## STAFF REPORT

SUBJECT: Alexanders Landing Subdivision  
H-2022-0084

Annexation of 5.23 acres of land from RUT in Ada County to the R-8 zoning district and preliminary plat consisting of 24 building lots and 4 common lots for Alexanders Landing Subdivision.

### A. Annexation Legal Description and Exhibit Map

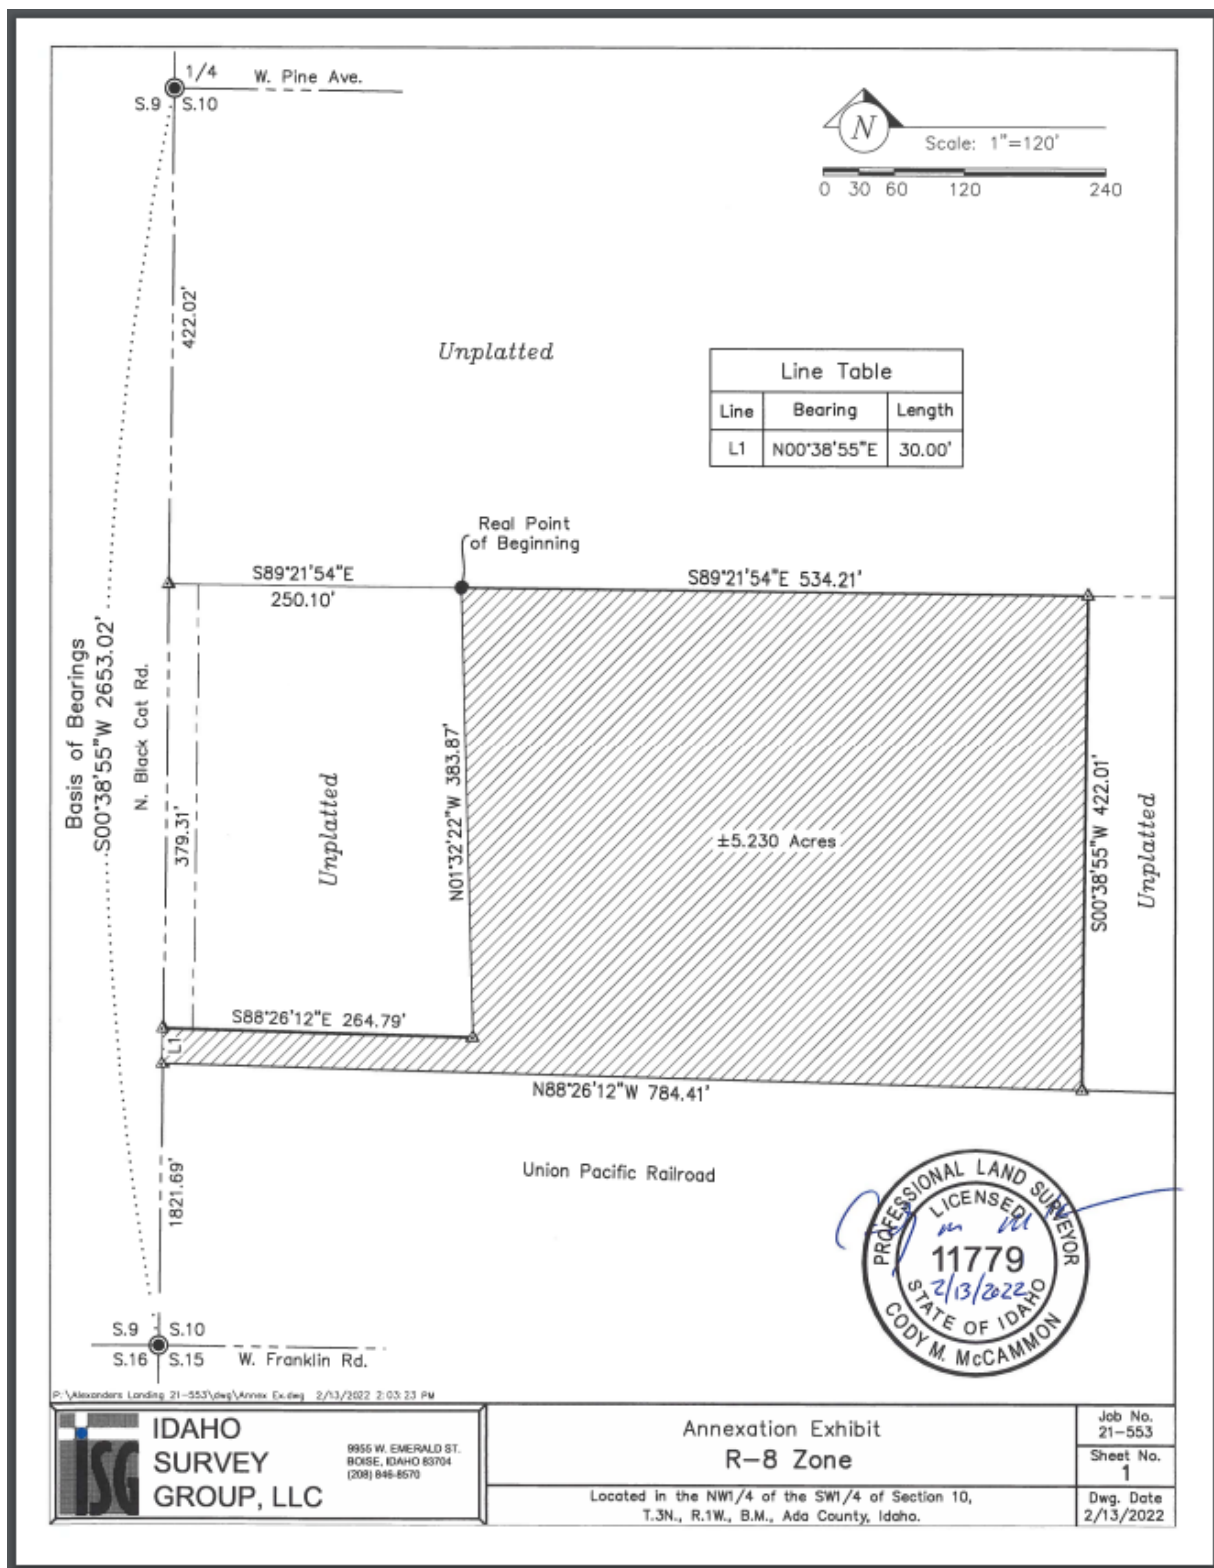
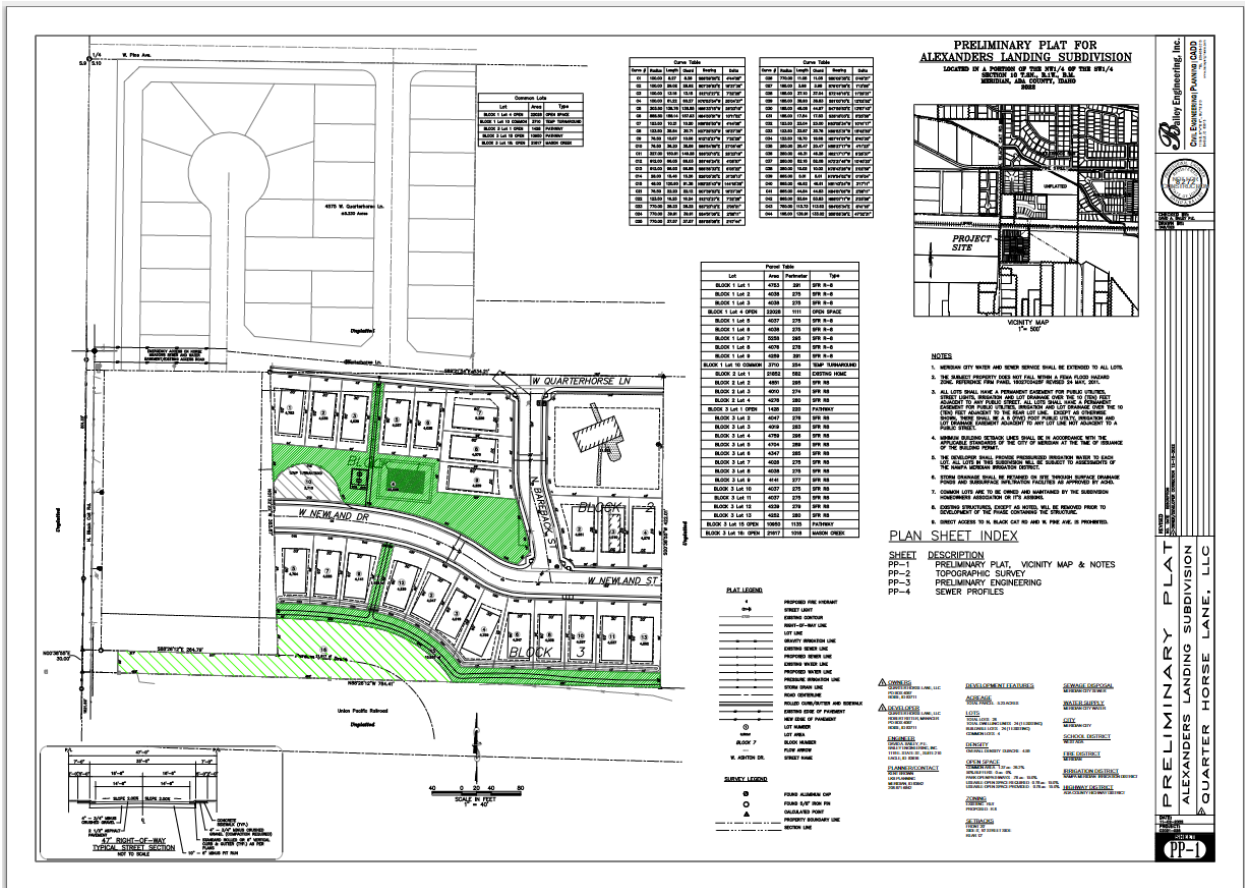
The Applicant proposes to annex 5.23 acres of land with an R-8 zoning district. A legal description and exhibit map for the annexation area is included in Section VIII.A. This property is within the City’s Area of City Impact boundary. **The annexation legal description submitted does not include to the centerline of the railroad tracks. The Applicant should submit a revised legal description of the property proposed to be annexed that encompasses the area to the centerline of the railroad tracks 15 days prior to the City Council Hearing.**

The property is contiguous to City annexed land to the north and is within the City’s Area of City Impact boundary. A legal description and exhibit map of the overall annexation area for the R-8 zoning districts are included in Section VIII.A.
